Service Bulletin

Bulletin No.: PI0432D

Subject: Shorter Front Bumper Fascia Air Deflector Available for Service

Models: 2011-2014 Chevrolet Volt

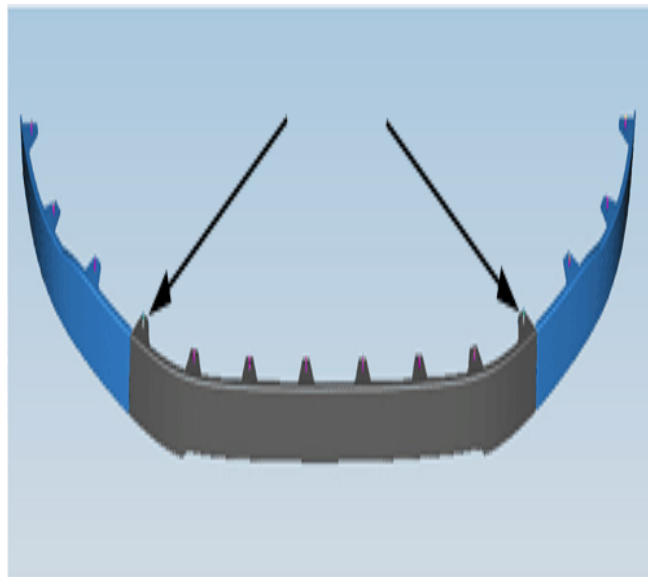
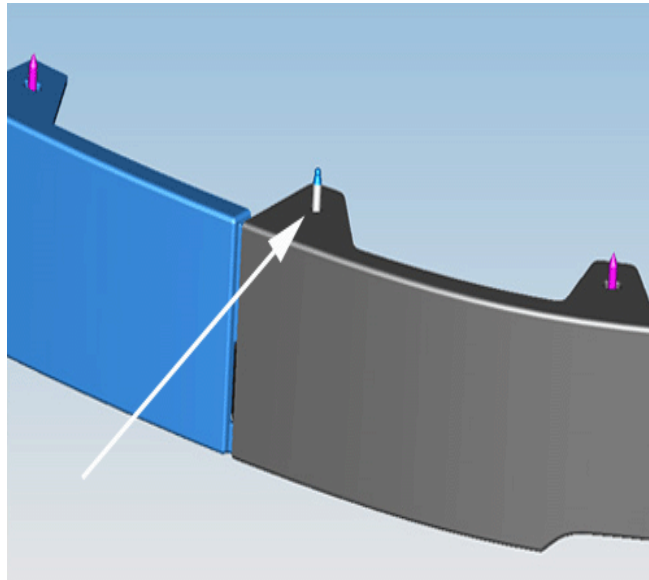
Some customers may comment about the low ground clearance of the front bumper fascia air deflector. The air deflector contacts the ground, scraping at short inclines, because there is not enough clearance between the ground and the front bumper fascia air deflector on an inclined surface.

A shorter front bumper fascia air deflector is available for service. Customers have the option to install the front bumper fascia air deflector, which has a higher clearance. The current clearance is 95 mm (3.7 in), the shorter front bumper fascia air deflector brings the clearance up to 125 mm (4.9 in).

2582397

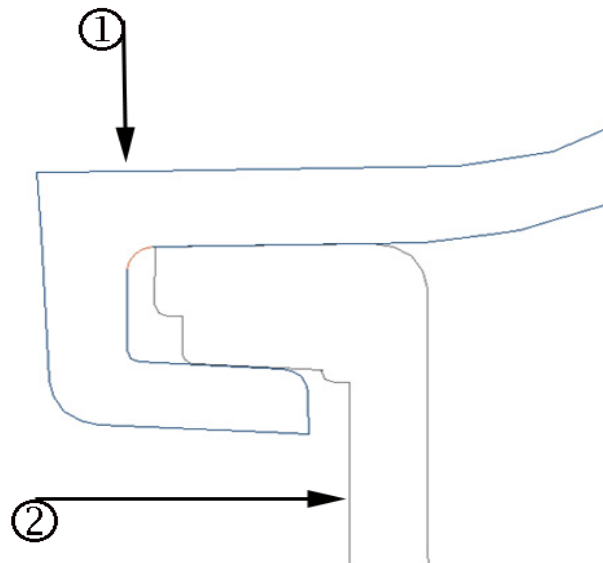
1. The two screws shown above are preinstalled at the plant and need to be removed from the wheelhouse liner prior to air deflector installation. Reinstall these screws first when installing the air deflector.

2592681

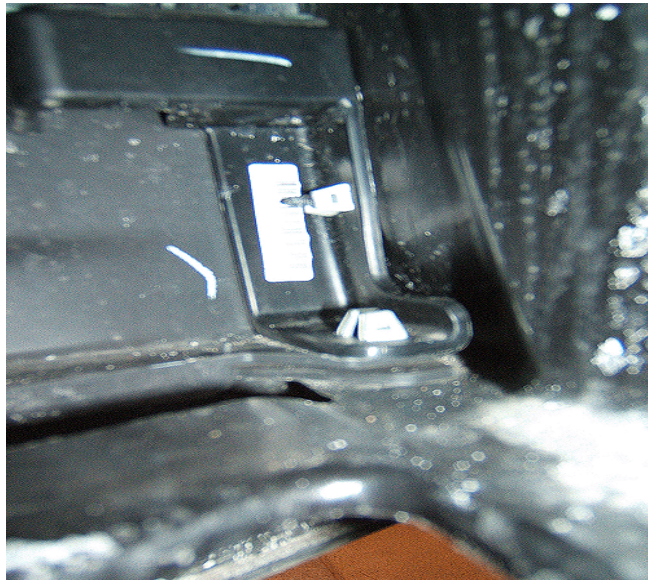
2. The air deflector (2) needs to be fully seated into the "C" channel on the lower fascia (1) as part of the assembly. Insertion into the "C" channel is a tight fit.
3. Prior to installing the screws, line up all three pieces of the air dam to the fascia first.
